D&A Statement Addendum

63 -71 High Street, Hampton Hill

Following submission a number of concerns were raised by the Local Planning Authority. Rolfe Judd Architecture have been appointed to address these comments and revised the proposals by 3S Architects accordingly.

**Revised Basement Plan**

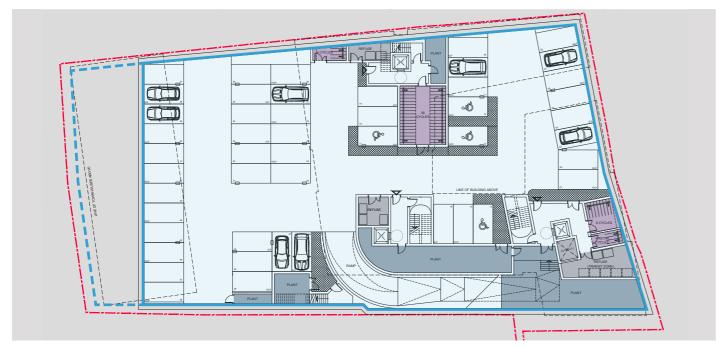
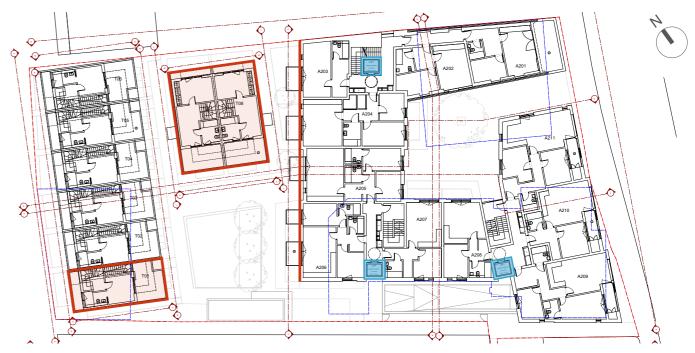
- · Smaller basement, reducing excavation.
- Townhouse lower ground level accommodation and private garages omitted. Secure cycle enclosure and refuse store moved for the townhouses to Ground Floor level.

**Revised Second Floor Plan**

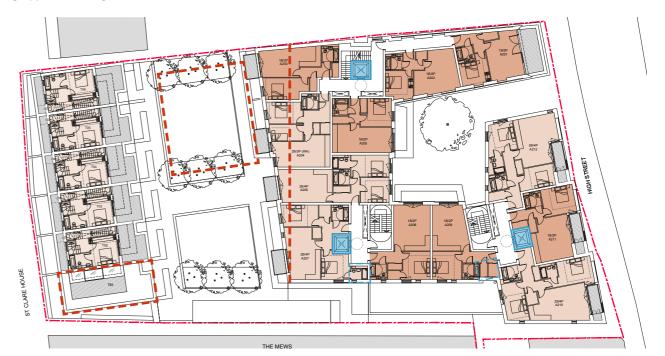
- Omission of central semi-detached Townhouses. Townhouse T01 reduced in height by 1 storey.
- Repositioning the angle of the main apartment building's rear west garden elevation.
- Enlargement of rear communal garden: improved outlook from units.
- Lift cores set further into the main body of the building to reduce their visible scale.

### 3.2 Views, light, visual connection

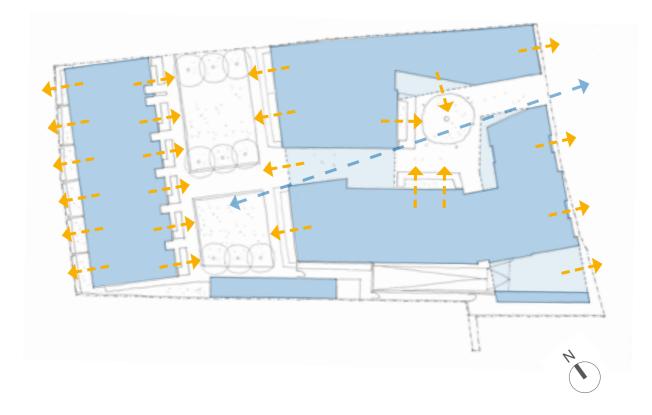
- Careful consideration to orientation and screening mitigates overlooking.
- Omission of the central semi-detached townhouses has improved the outlook for the rear elevation apartment units and remaining Townhouses.
- Each dwelling benefits from connection to spaces of interest.
- Responding to inter-relationships to adjoining development to the south
